Discussion of “Mechanics of Progressive Collapse: Learning from World Trade Center and Building Demolitions” by Zdeněk P. Bažant and Mathieu Verdure

March 2007, Vol. 133, No. 3, pp. 308–319.
 DOI: 10.1061/(ASCE) 0733-9399 (2007)133:3(308)

Discussion of "Mechanics of Progressive Collapse: Learning from World Trade Center and Building Demolitions" by Zdeněk P. Bažant and Mathieu Verdure

Closure to “Mechanics of Progressive Collapse: Learning from World Trade Center and Building Demolitions” by Zdeněk P. Bažant and Mathieu Verdure

Fig. 1. (a) Postulated plastic joint location; (b) deformed shape; (c) resistance deflection plot; and (d) the thin wall section at the upper segment of building

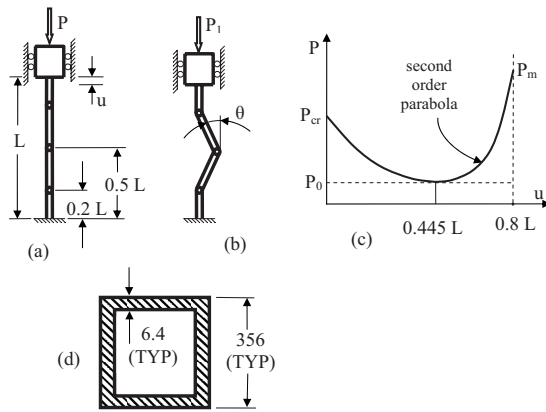
The number of those segments was not available, so we assumed it to be 6. The square column section shown in Fig. 1(d) is the thinnest one. (Corner rounding was not shown.) It is also the relevant one for the initiation of collapse. Close to the base of building, the outer dimension is the same, but the wall thickness is 101.6 mm. The properties of this lightest section are as follows:

The first phase of column squashing in the plastic range is as shown in Fig. 1(c), with the rotation angle of $\theta=75^\circ$. The absorbed strain energy, up to that intermediate point, is

The final compacted length is taken as $0.2L$ and the $P-u$ curve (load-resistance) is assumed to be the second-order parabola, tangent to the horizontal at the intermediate point and reaching the value of $P_m=2P_{cr}$. This peak load is to be applied for a very short time only, not sufficient to buckle the column. Besides, the floor mass is resisting some of the dynamically applied load.

With the compaction ratio of 0.2, the travel during the stiffening part of the movement is $u_2=0.8L-0.445L=0.355L=1,289 \text{ mm}$. The minimum and the maximum forces over this displacement are, respectively

versus axial displacement u of a column (sketched in his figure 1(c) and redrawn to scale as the upper curve in Fig. 2 right) is not correct and grossly overestimates the energy dissipation in the column (note that what the discussor denotes as P is in the paper denoted as F). The correct curve (Fig. 2, left), based on the theory of plastic large-deflection buckling (Bažant and Cedolin 2003, Sec. 8.6), is given by Eq. 8 in Bažant and Zhou (2002) and reads

- The discussor's expression $P_0 = M_0/0.3L \sin \theta_2$ for the lowest point of his $P(u)$ curve is not correct. This expression was apparently derived from equilibrium of the column segment as a free body, as shown in Fig. 5(c) of Bažant and Zhou 2002, but only one of the two plastic moments M_0 acting at the segment ends (shown in that figure) was considered. Considering both plastic moments in that figure, one gets the correct expression $P_0 = 2M_0/0.3L \sin \theta_2$.

- The discussor assumes the upper and lower plastic hinges to be located at distances $0.2L$ from the column ends, rather than at the column ends. This assumption causes the rotation $\theta = 75^\circ$ to be reached when the story height L is reduced only by $u = 0.445L$ [Fig. 1(c)] rather than by $0.8L$.

- For the curve $P(u)$ beyond the point $u = 0.445L$, the discussor assumes a rising parabola [see his Fig. 1(c) and Fig. 2 right, in this closure] instead of a continued softening response up to $u = 0.8L$ (Fig. 2 left). This assumed parabola greatly exaggerates the estimate of energy dissipation in the column. There is no reason for increasing resistance $P(u)$ until the debris is fully compacted. The debris behaves like gravel. From soil mechanics, it is known that when the density of a random system of particles such as sand, gravel, or debris is less than a certain critical density, the neighboring particles do not have a sufficient number of contacts to support load. Thus, thinking that flying and colliding debris in the tower can support any load is a mistake. Upon reaching the critical density (which the discussor assumes to occur at $u = 0.8L$), all the particles of debris suddenly lock in a sufficient number of contacts preventing their relative movements, and only then the compacted debris can support load. Hence, the $P(u)$ curve should

- The discussor terminates the rising parabola at the load $P_m = 2P_{cr} = 8,584$ kN, i.e., at double the plastic critical load. But this guess is unrealistic. It scales the entire rising parabola upward and thus again enormously exaggerates the energy dissipation in the column (note that here $P_{cr} = P_t = \sigma_0 A = \text{tangent modulus load} = \text{plastic limit load}$ because a long yield plateau exists; $\sigma_0 = \text{yield strength}$).

Fig. 1. Evolution of initial simultaneous crush up and crush down and its arrest within the first story being crushed

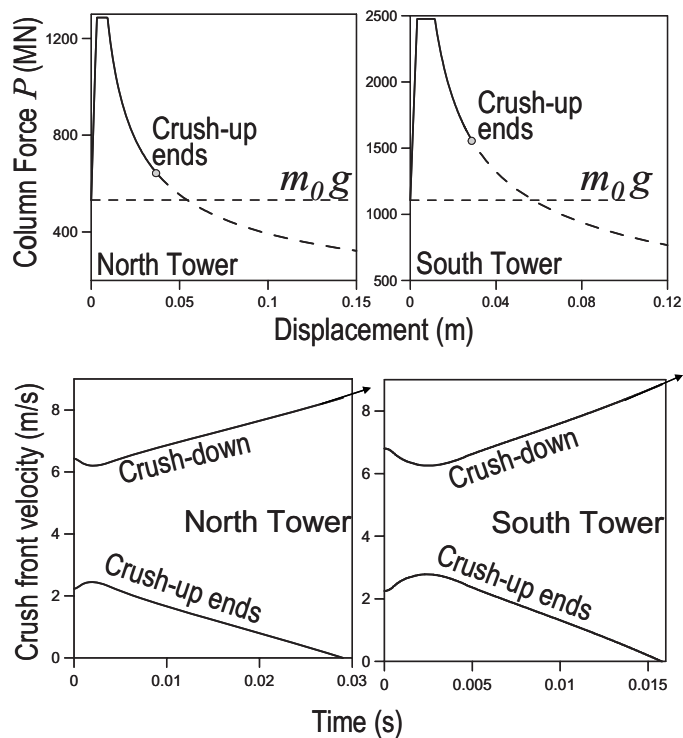
4. **Can Crush-Up Proceed Simultaneously with Crush Down?** It can, but only briefly at the beginning of collapse, as mentioned in the paper. Statements such as “the columns supporting the lower floors . . . were thicker, sturdier, and more massive,” although true, do not support the conclusion that “the upper floors (i.e., the floors comprising Part C) would be more likely than the lower floors to deform and yield during collapse” (deform they could, of course, but only a little, i.e., elastically). More-detailed calculations than those included in their paper were made by Bažant and Verdure to address this question. On the basis of a simple estimate of energy corresponding to the area between the load-deflection curve of columns and the gravity force for crush down or crush up, it was concluded at the onset that the latter area is much larger, making crush-up impossible. We have now carried out accurate calculations, which rigorously justify this conclusion and may be summarized as follows.

Fig. 1 shows the calculated evolution of displacement and velocity during the collapse of the first overlying story in two-way crush. The result is that the crush-up stops (i.e., $|\dot{x}|$ drops to zero) when the first overlying story is squashed by the distance of only about 1.0% of its original height for the North Tower, and only by about 0.7% for the South Tower (these values are about 11 or 8 times greater than the elastic limit of column deformation). Why is the distance smaller for the South Tower even though the falling upper part is much more massive? That is because the initial crush-up velocity is similar for both towers, whereas the columns are much stronger (in proportion to the weight carried).

The load-displacement diagram of the overlying story is qualitatively similar to the curve with unloading rebound sketched in Fig. (4c) of the paper and accurately plotted without rebound in Fig. 3 of the paper. The results of accurate computations are shown by the displacement and velocity evolutions in Fig. 1.

only an imperceptible difference in the results. The crush-up simultaneous with the crush down is found to have advanced into the overlying story by only 37 mm for the North Tower and 26 mm for the South Tower. This means that the initial crush-up phase terminates when the axial displacement of columns is only about 10 times larger than their maximum elastic deformation. Hence, simplifying the analysis by neglecting the initial two-way crushing phase was correct and accurate.

Fig. 2. Comparison of the correct axial load-displacement curve $P(u)$ of column (left) with the discussor's incorrect curve (right) plotted according to his calculations (note that his Fig. 1(c) is a sketch not drawn to scale)

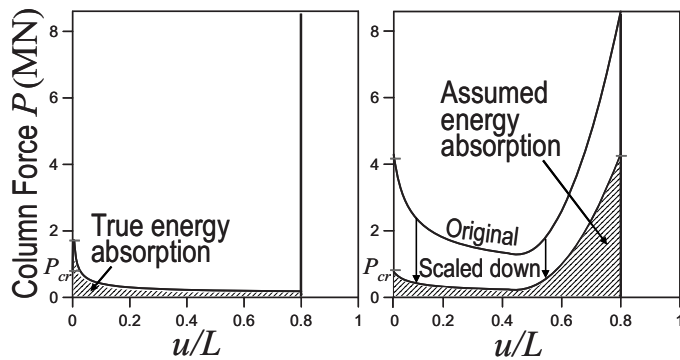
1. Load-Displacement Curve of Columns and Energy Absorption Capacity: The discussor's curve of axial load P

descend up to the moment of critical density of debris, which is about the same as the density of the heap on the ground, and then rise sharply, as shown in Fig. 3 of the paper and also in Fig. 2, left, of this closure.

Misled by the omission of inertia force (Fig. 3), the discussor reduces the critical load P_{cr} by the factor of 5.59 to make it equal to the gravity load (Fig. 2, right). This is impossible. The column strength is an objective property of the material and of the column geometry and not some fictitious property that can be adjusted according to the load to achieve static equilibrium.

Fig. 3. Forces in dynamic equilibrium of upper Part C of tower at the beginning of crush down

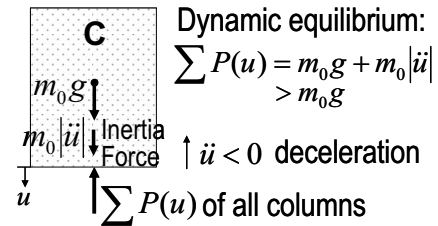
2. **Does Excess of P_{cr} over Gravity Load m_0g Imply Arrest of Collapse?** Not at all, and this point is generally misunderstood by critics. In the discussion section entitled “Initial Phase of Collapse—Heavily Damaged Story,” the premise that “to cause initiation of failure, the buckling force P_{cr} had to be reduced to the level of applied load,” would be correct in statics but not in dynamics, where the inertia forces must be taken into account, according to the d’Alembert principle.

The fact that P_{cr} exceeds the applied load (i.e., $P_{cr} > m_0g$) does not mean that the motion of the falling mass would get instantly arrested (which would require an infinite upward acceleration $|\ddot{u}|$ and thus an infinite resisting force). Rather, it simply means that the downward motion will continue as decelerated (Fig. 3) until the sum of the resisting

forces $P(u)$ of all columns of the story (which begins with the plastic critical load P_{cr}) drops below m_0g . After that, the resistance $P(u)$ becomes less than m_0g , which means that the downward motion will be accelerated. This is clear from the calculated diagrams shown in the second and third rows of Fig. 4 in the paper.
